FROM SERIAL NO: AY5573 ONWARDS

FIG 1. 2 PART PISTON

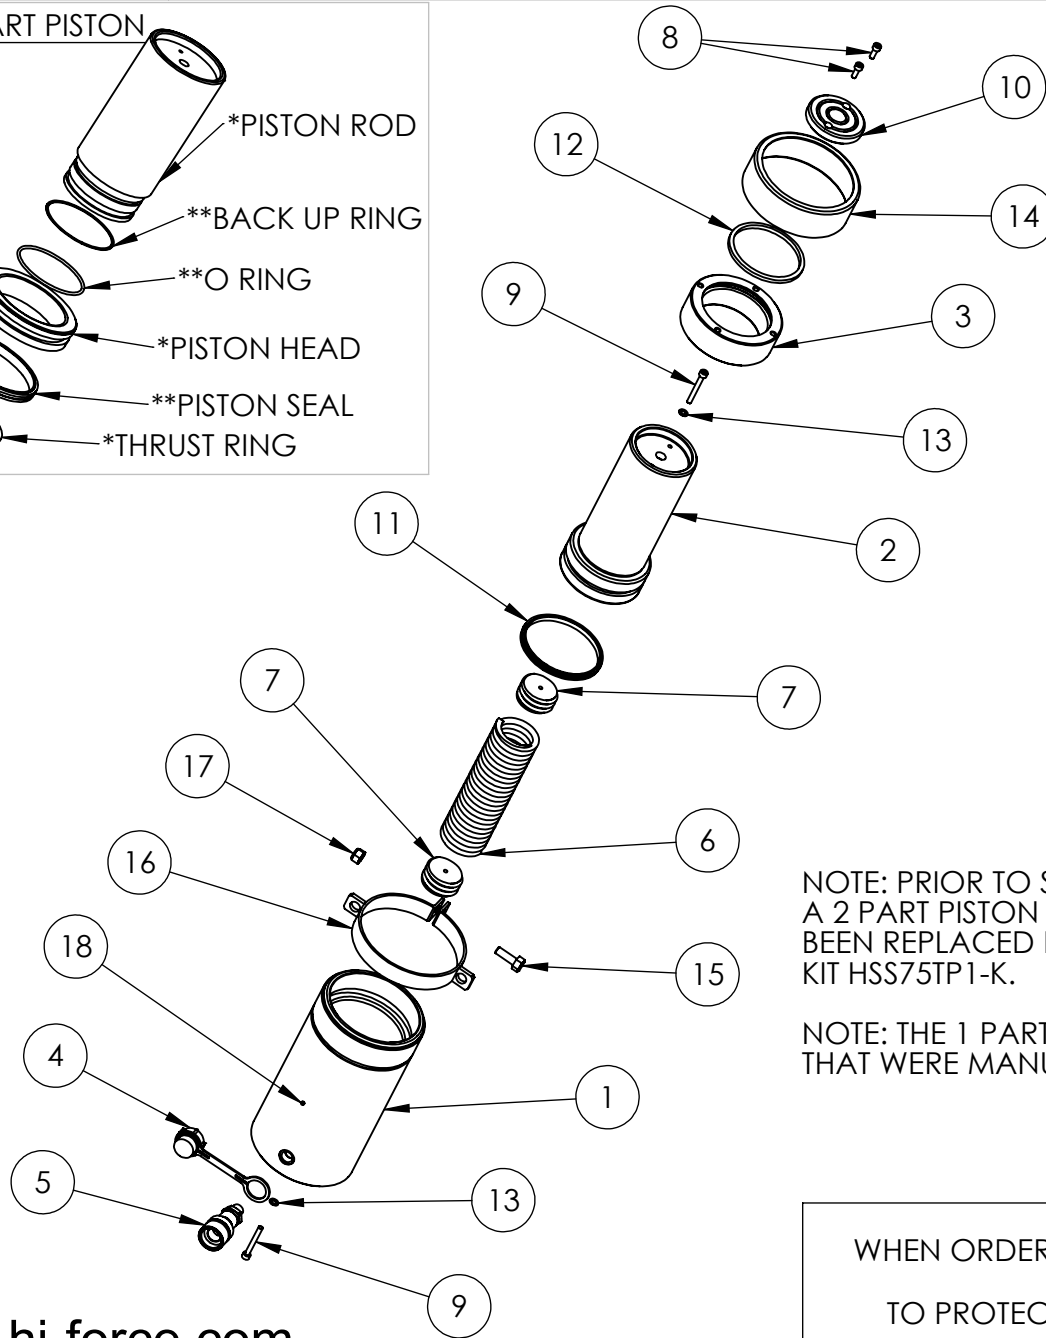
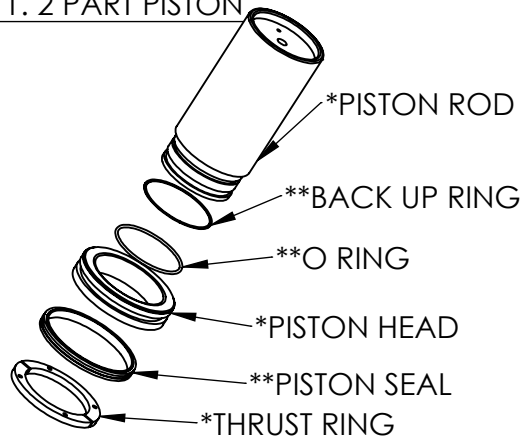
NOTE: PRIOR TO SERIAL NO. AY5573 THE CYLINDERS WERE MANUFACTURED WITH A 2 PART PISTON (FIG 1). PARTS MARKED * ARE NOT AVAILABLE, THESE PARTS HAVE BEEN REPLACED BY ITEM NO. 2. PARTS MARKED UP ** ARE AVAILABLE IN SERVICE KIT HSS75TP1-K.

NOTE: THE 1 PART PISTON DESIGN IS FULLY INTERCHANGEABLE WITH THE CYLINDERS THAT WERE MANUFACTURED WITH A 2 PART PISTON.
